ADDENDUM NO. 3

**REQUEST FOR TENDERS #: T-683-24
REPLACEMENT OF ROOF AT WOODLANDS OPERATION CENTRE, 1179 BRONTE ROAD,
OAKVILLE, ON L6M 3L1**

This Addendum No. 3, issued Monday, May 6, 2024, must be incorporated into and made part of the above noted Request for Tenders Document.

6 SKYLIGHT DETAIL
A4 SCALE: 1:8

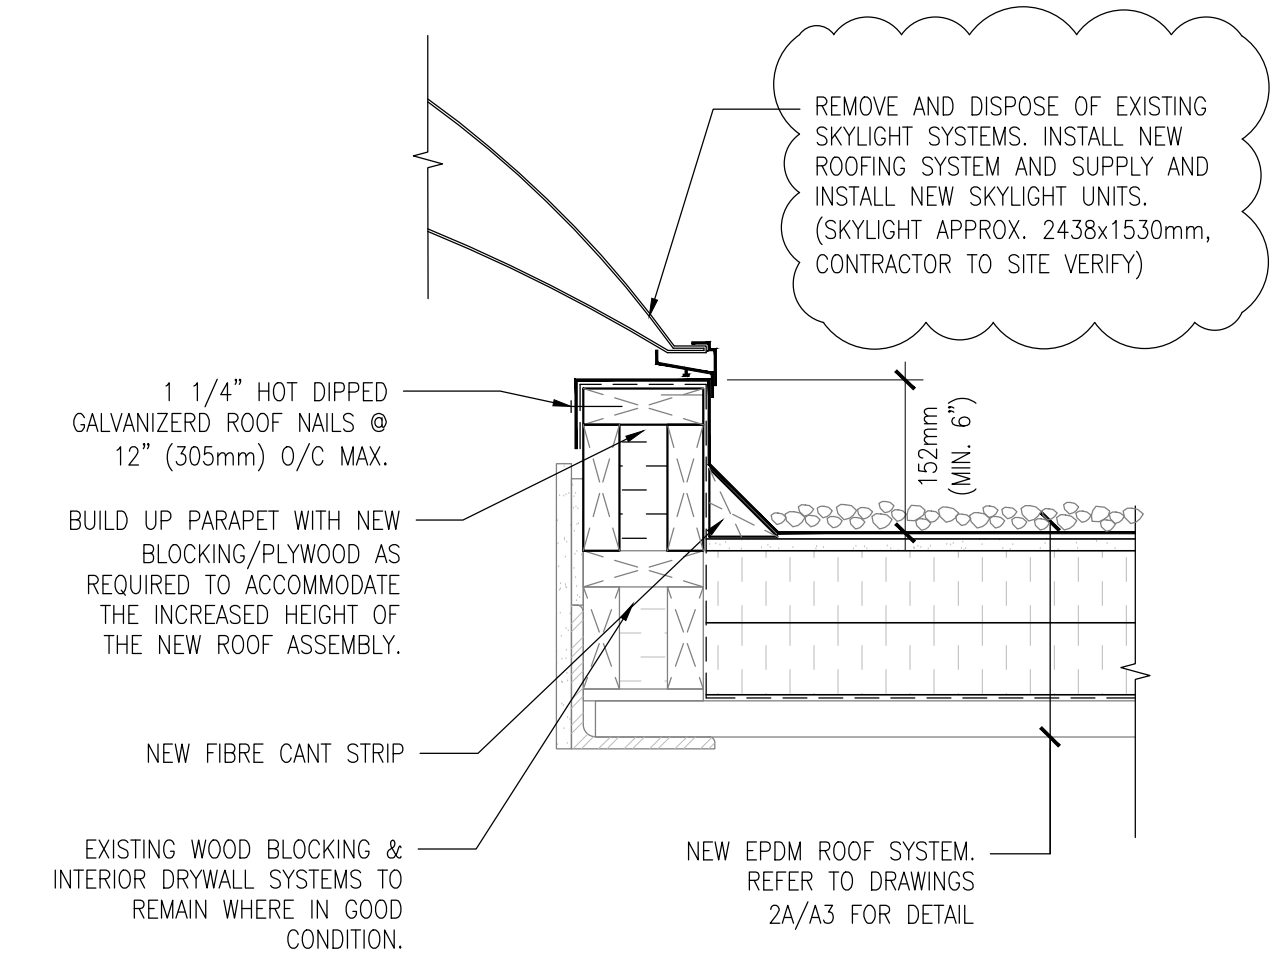
Question 1: Note on A2 drawing states remove and dispose existing skylight system (typical). However, 6/ A4 detail says remove and store existing skylight and reinstate skylights. Please clarify.

Answer 1: Skylights are to be removed and disposed of. Refer to the detail 6/A4 (Skylight Detail) of Drawing A4, Revision 3 attached hereto.
